PLANNING BOARD REPORT PORTLAND, MAINE

82 Hanover Street Redevelopment
Level III Site Plan Review
2018-042
Tom Watson & Co, LLC

Submitted to: Portland Planning Board Date: May 11, 2018 Public Hearing Date: May 17, 2018	Prepared by: Nell Donaldson, Senior Planner CBLs: 34-G-1, 2, 3, 4, & 5 Project #: 2018-042
--	--

Figure 5: Discontinued Lancaster Street right-of-way, with proposed 10' pedestrian easement.

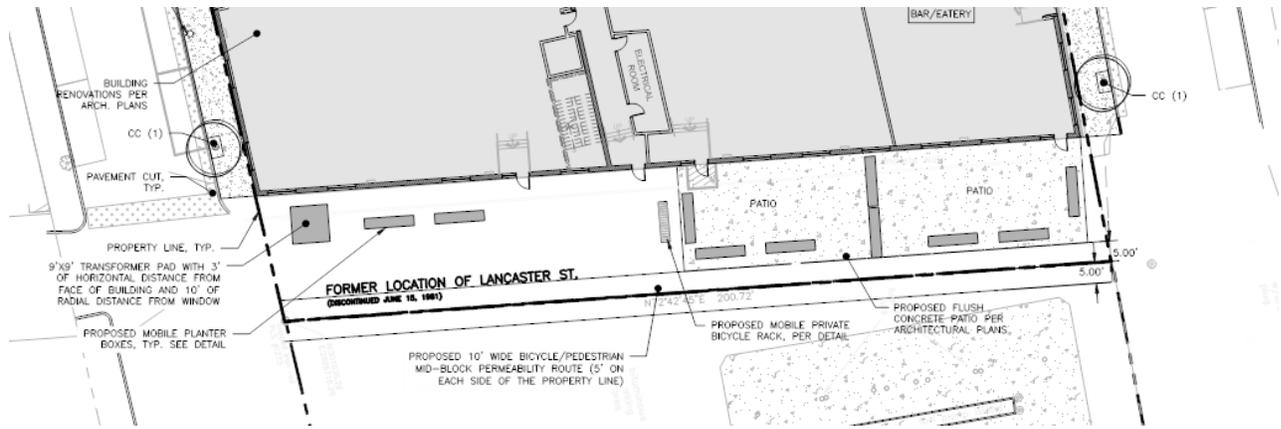
The final plans show additional points of pedestrian access across the site within the discontinued Lancaster Street right-of-way at the rear of the building. It should be noted that at the time of this review, the city maintains a public easement in the discontinued Lancaster Street right-of-way. This public easement confers rights of pedestrian and vehicular access over the entire 30' width of the discontinued right-

of-way. Given the findings of the traffic analysis, which shows that the majority of the site’s vehicular traffic impact will be directed to the north, the applicant has requested that this easement be extinguished in favor of a 10’ wide public pedestrian easement, which would continue to allow members of the public to access uses along the building’s southern frontage. No vehicular access in the Lancaster Street right-of-way is proposed. The discontinuance of the public easement requires action by the City Council.

Assuming that the Council takes action to discontinue the public easement, the applicant has drafted the final plans to show the proposed 10’ wide public pedestrian easement, 5’ of which is proposed to lie on the 82 Hanover site, and 5’ of which is proposed to lie on the adjacent 44 Hanover Street property, which is the subject of a separate purchase and sale agreement between the applicant and the City of Portland (Figure 5). This easement would allow mid-block permeability for pedestrians and provide access to the program proposed for the rear of the building, including the brewery and bar/restaurant. Staff has suggested a condition of approval which conditions all planned Lancaster right-of-way improvements on the discontinuance of the public easement and, assuming that the Council supports the discontinuance of the public easement, requires the provision of this public pedestrian easement.

3. Approval of all site plan improvements shown in the Lancaster Street right-of-way are conditioned upon the City Council formally discontinuing the existing public easement in this right-of-way and the applicant providing a 10’ wide public pedestrian easement as shown on the site plan between Parris Street and Hanover Street in the vicinity of the Lancaster Street right-of-way for review and approval by Corporation Counsel, the Department of Public Works, and the Planning Authority;
